International Technical Service Bulletin

NUMBER: I26-807-03

Owner Manual Addendum - Headlamp Bulb Replacement

2004 (PL) Neon

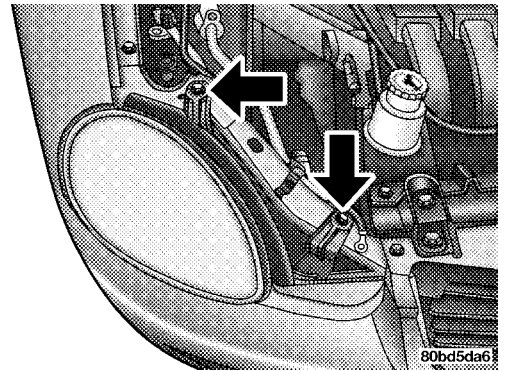
1. Remove two screws from the headlamp module and pull module from the vehicle.

NOTE: The headlamp module is located to the fender by a molded pin. Pull the outboard side of the headlamp straight out until the molded pin clears the fender, then slide the headlamp out from behind the bumper fascia and grille.

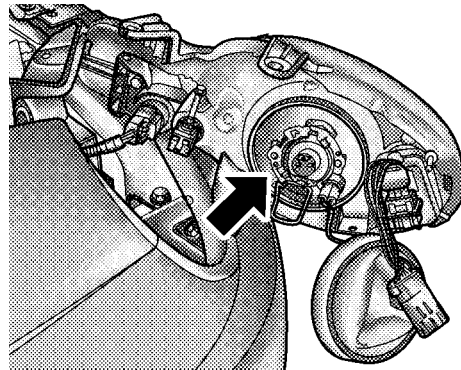
2. Disconnect electrical connector and remove the rubber boot seal.

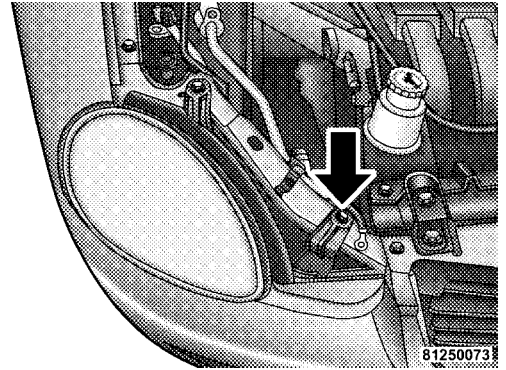
3. Remove retaining ring and replace bulb.

During installation, be sure when tightening the inboard screw, to only tighten until the rubber grommet on the screw starts to compress against the headlamp module housing.
